From: Julie A Zimdars <Julie.Zimdars@ramboll.com>
Sent: Wednesday, January 26, 2022 2:37 PM
To: Amadi, Eric A - DNR
Cc: Mike Kellogg
Subject: FW: BRRTS 02-41-553761 and 06-41-560068 Connell Wabash Site - RAOR Addendum/Pre-Design Work Plan (Rev 2)
Attachments: Sewer Removal Details_Figure1B_Connell Wabash RAOR Addendum R2_220121prnt.pdf; MMSD Sewer line 20121806627.pdf

Hi Eric – On behalf of Connell Aluminum Properties, attached is the *Addendum (Revision 2) to the Remedial Action Options Report (RAOR) and Pre-Design Sampling Work Plan* for the Former Koppers Tar Plant and Wabash Alloys Site that incorporates WDNr comments received on July 9, 2021.

PLANNED SEWER REMOVAL AND PCB SOIL EXCAVATION PLAN ABOVE SEWER TO REMAIN

RAOR ADDENDUM
 FORMER WABASH ALLOYS
 9100 SOUTH 5TH AVENUE
 OAK CREEK, WISCONSIN

FIGURE 1B
FIGURE 9 (REV. RAOR REPORT)

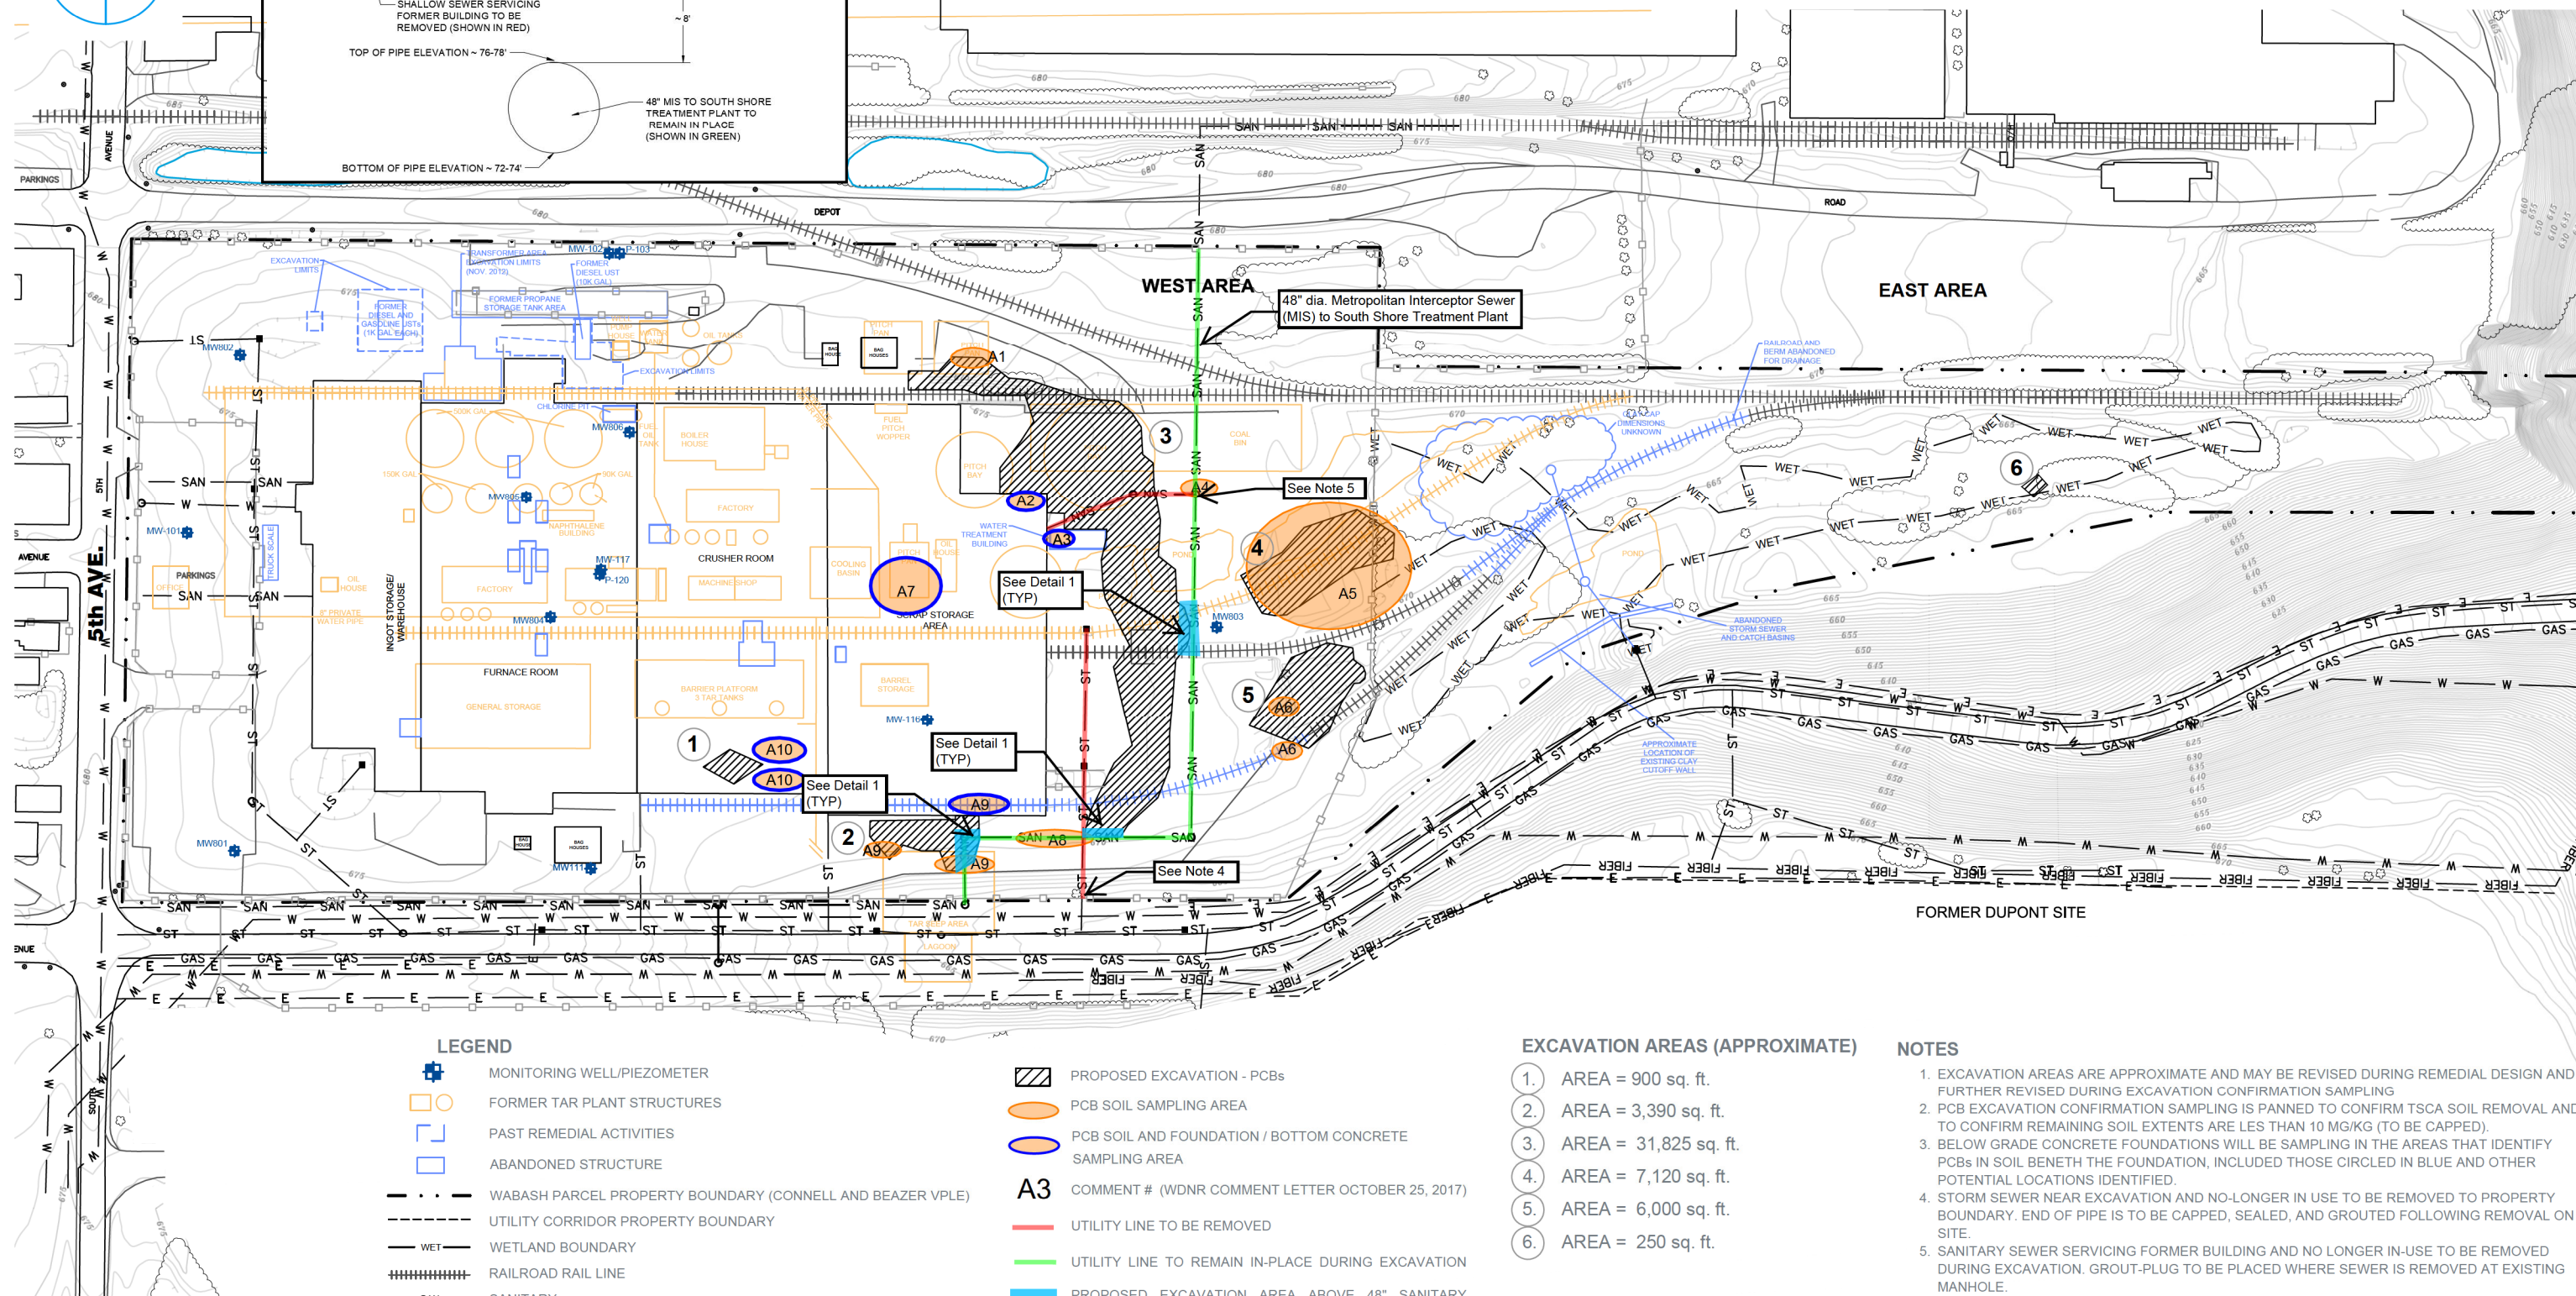
I presented the subject site report to the VPLE Committee today (23Nov2021). The Committee requests a map/figure showing the sewers (referenced in the subject site report under the heading, "Excavation Near Sewer Structures"), that will remain in place and those that will be excavated. Also, show areas where materials will be removed within the indicated five (5) feet of the sewer structures known as critical zone and the reduced critical zone of 1.5 feet.

In response to your email dated November 23, 2021, Ramboll has prepared the attached Figure (Figure 1B, *Connell Wabash RAOR Addendum R2*) to identify the sanitary and storm sewers that will remain in place or be removed during proposed excavation of PCB-impacted soil areas. Ramboll is providing these additional details at the RAOR stage as requested by the DNR. Typically this type of detail would be addressed in the subsequent NR724 Remedial Design Report. As a reminder, we are still awaiting approval of the pre-design sampling effort that DNR previously requested and we detailed in the Pre-Design Sampling Work Plan that was submitted on September 28, 2021 (included with RAOR Addendum Revision 2). We would like to point out that the details provided herein could change based on that upcoming sampling data.

The sewers identified for removal (shown in red) associated with proposed PCB soil excavations include:

1. One (1) storm sewer within the former loading dock area located east of the historic footprint of the building. The 12" storm sewer connects into the large storm sewer beneath the City corridor access road. The storm sewer is to be removed within the property boundaries then cut, sealed, and grouted at the property line or with City approval, potentially at the large sewer connection point.
2. One (1) sanitary service sewer east of the building footprint. The sanitary sewer previously serviced the building and connects to the 48 inch MIS (MMSD Metropolitan Interceptor Sewer) gravity sanitary sewer that transects the property. The building sanitary line will be removed during PCB soil excavation to the connection point with the 48 inch sanitary sewer. The sanitary service line will have a grout-plug installed at the connection manhole to the main sanitary sewer.

The 48 inch MIS sanitary sewer that gravity flows north to South Shore Treatment Plant, which is located east and south of the former building footprint, will be preserved and operational throughout PCB remedial activities (shown in green). The MMSD sewer map with relative elevations (manhole rim and pipe inverts) is attached. As shown on Detail 1/Figure 1B, shallow PCB-impacted soil is expected to be removed to 2-4 feet in depth in areas near and above the MMSD sewer line. Since it is expected that around 8 feet or more of separation will exist between both the bottom of the excavation and also the bottom of shallow sewer removal, we are not expecting the excavation to be within the five (5) foot critical zone where soft dig techniques would be specified, such as hydro-vac or air knife. Three (3) areas are identified on the figure where this separation distance will be confirmed both during the forthcoming remedial design stage and also in the field during excavation work. The specifications for the excavation work will include these soft dig requirements in a potential case where the excavation could infringe upon the 5 foot critical zone. As indicated above, proposed excavation areas could expand or otherwise change once the new sampling data is collected and the effect on the sewer lines would require re-assessment.

Additional storm and sanitary sewers and water utilities are located to the west and south of the building footprint that are not nearby/within proposed PCB excavation activities. These utilities previously serviced the building and will be properly abandoned (e.g. removal and/or grout-plug at connections) as part of the proposed site grading, capping and restoration activities. Many of these utilities have previously been plugged with grout near the building edge during the 2012-2013 building demolition activities. These remedial design details are pertinent to the Remedial Design Report, and not a detail that is necessary for approval of the Remedial Actions Options report.
